Table 2.1 D.C. Cook Unit 2 LOCA/ECCS Analysis Summary

Results for the Cycle 5 Core Configuration (85% ENC Fuel)

ATTACHMENT 2
PROPOSED REVISION TO TECHNICAL
SPECIFICATION PAGES

FIGURE 3.2-4 RCS TOTAL FLOWRATE VERSUS R - FOUR LOOPS IN OPERATION

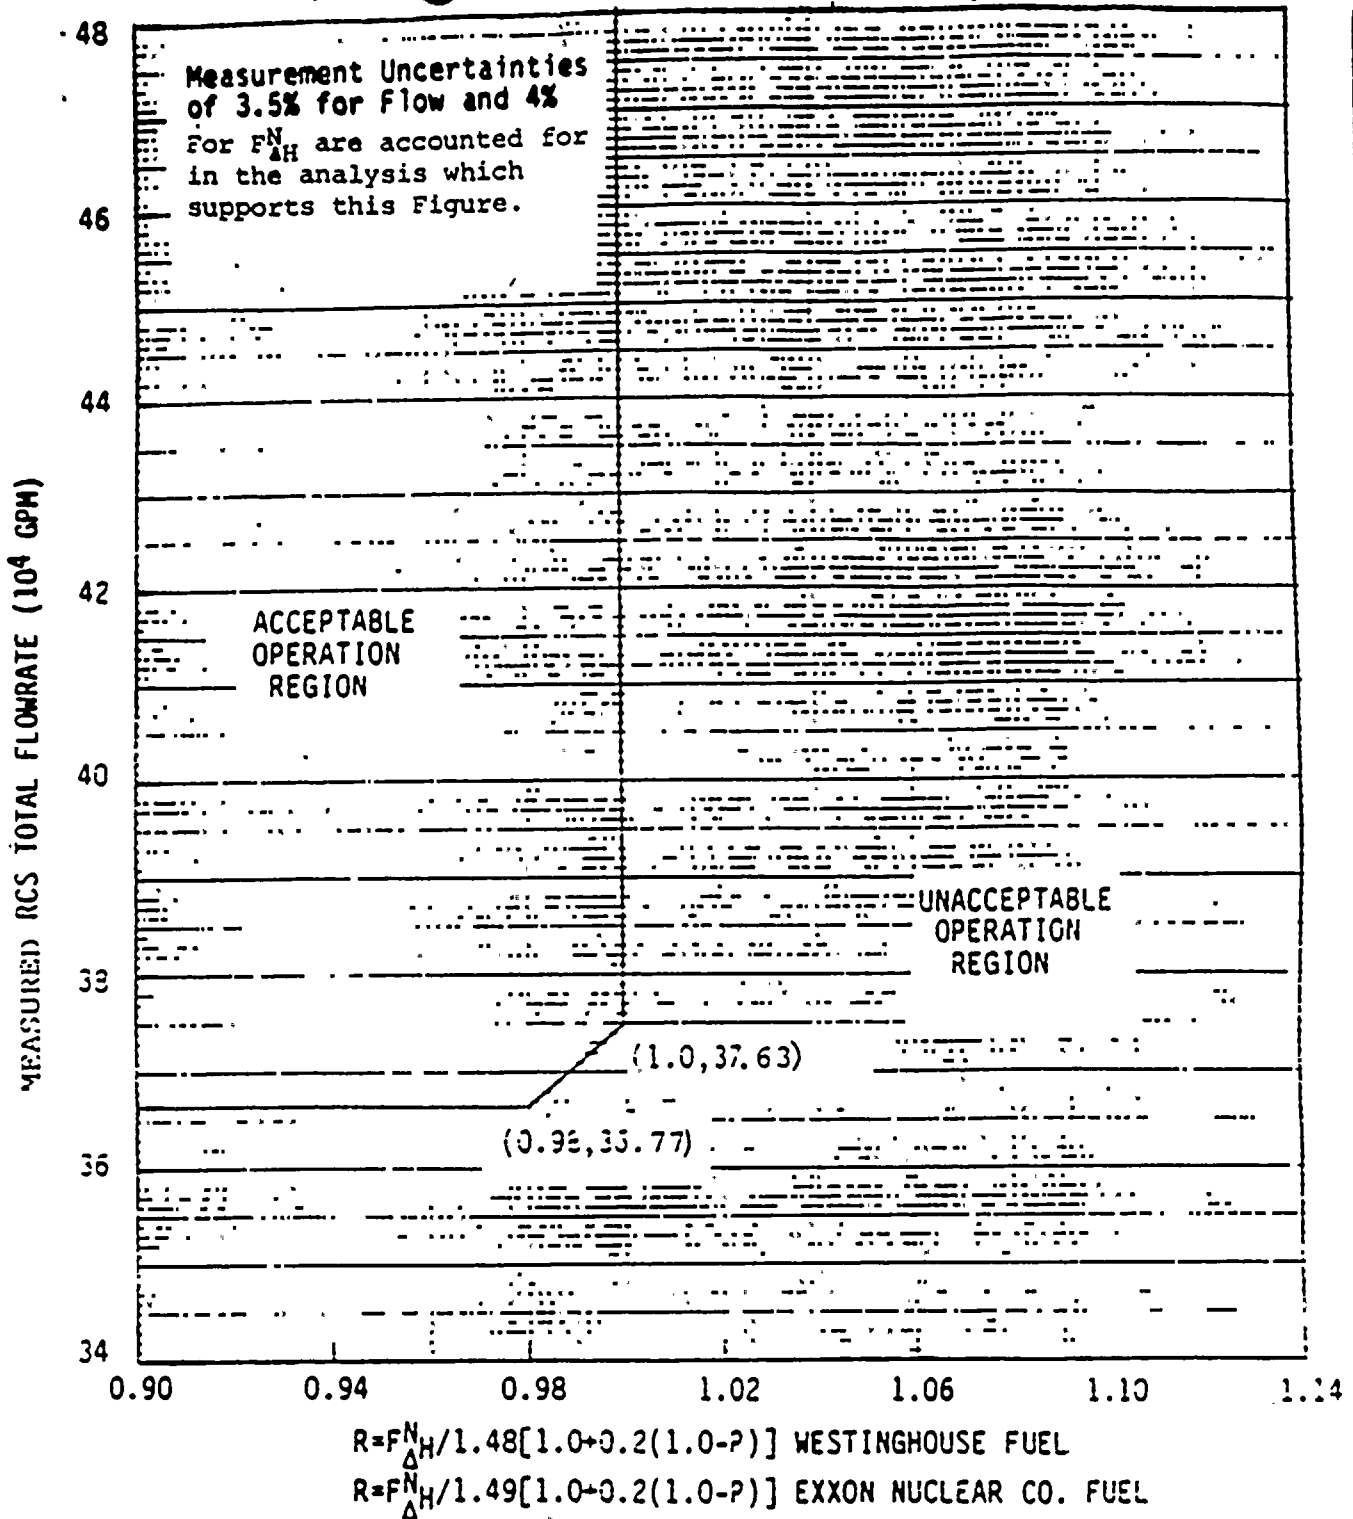
3.2.3 The combination of indicated Reactor Coolant System (RCS) total flow rate and R shall be maintained within the region of allowable operation shown on Figures 3.2-4 and 3.2-5 for 4 and 3 loop operation, respectively.

$$R = F_{NH}^N / 1.48 [1.0 + 0.2(1.0 - P)] \text{ WESINGHOUSE FUEL}$$

$$R = F_{NH}^N / 1.49 [1.0 + 0.2(1.0 - P)] \text{ EXXON NUCLEAR CO. FUEL}$$

FIGURE B 3/4 2-2 ILLUSTRATIVE EXAMPLE OF
 $F_{\Delta H}^N$ LIMIT VERSUS PERCENT THERMAL POWER FOR EXXON FUEL

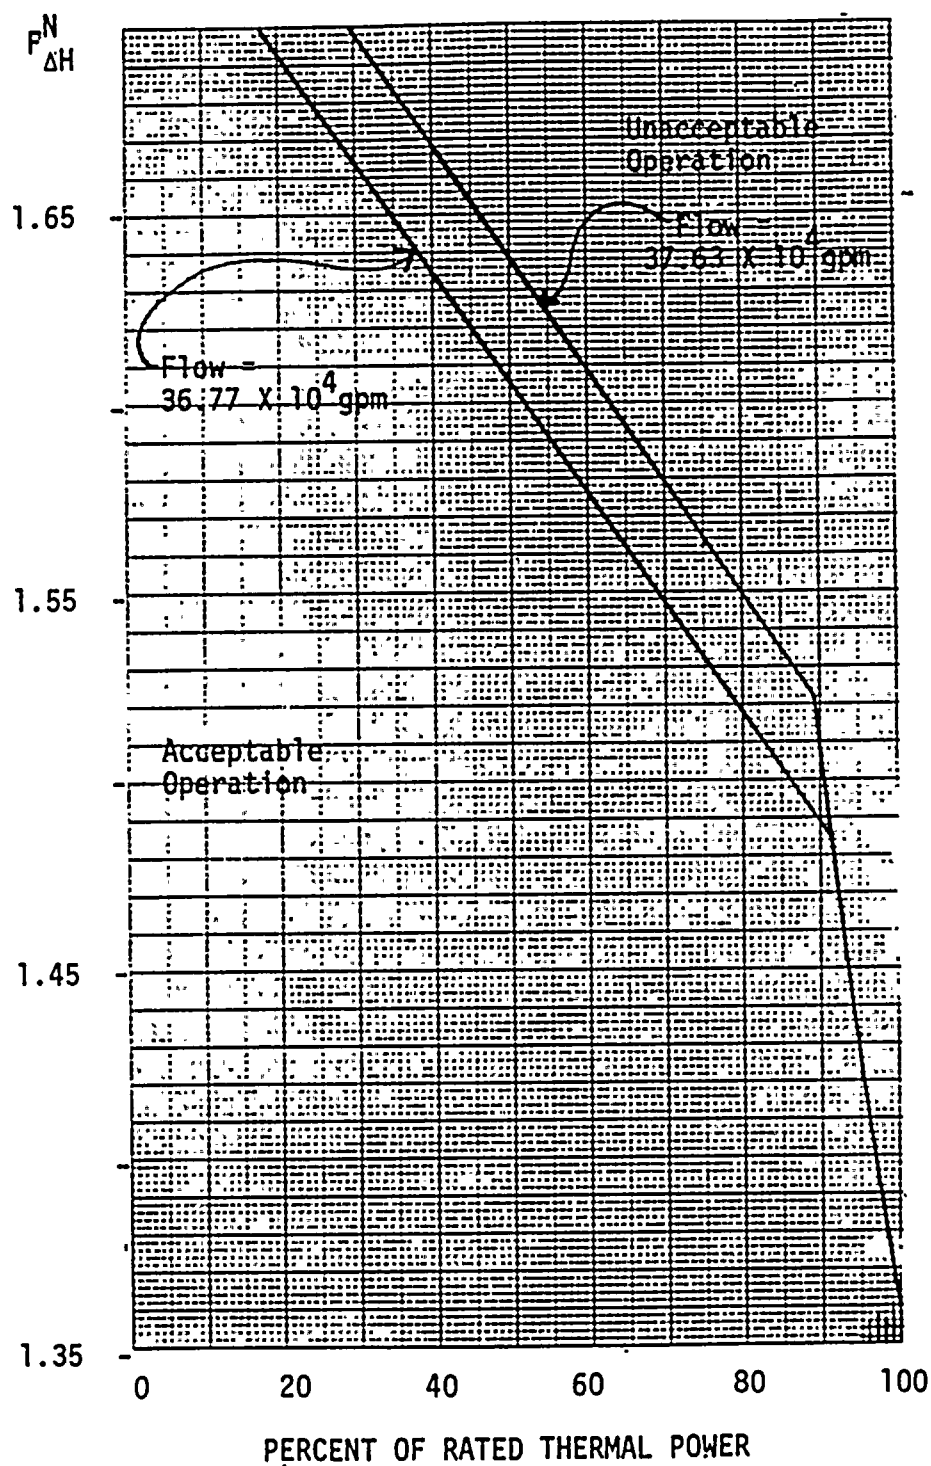
Figure B 3/4 2-2 displays two limiting DNBR $F_{\Delta H}^N$ curves for Exxon Nuclear Company fuel for flows of 36.77×10^4 gpm, and 37.63×10^4 gpm. Also displayed on Figure B 3/4 2-2 is the limit on $F_{\Delta H}^N$ which results from the LOCA analysis for Exxon Nuclear Company fuel. $F_{\Delta H}^N$ must be maintained below and to the left of both the applicable DNBR $F_{\Delta H}^N$ limit and the LOCA $F_{\Delta H}^N$ limit.
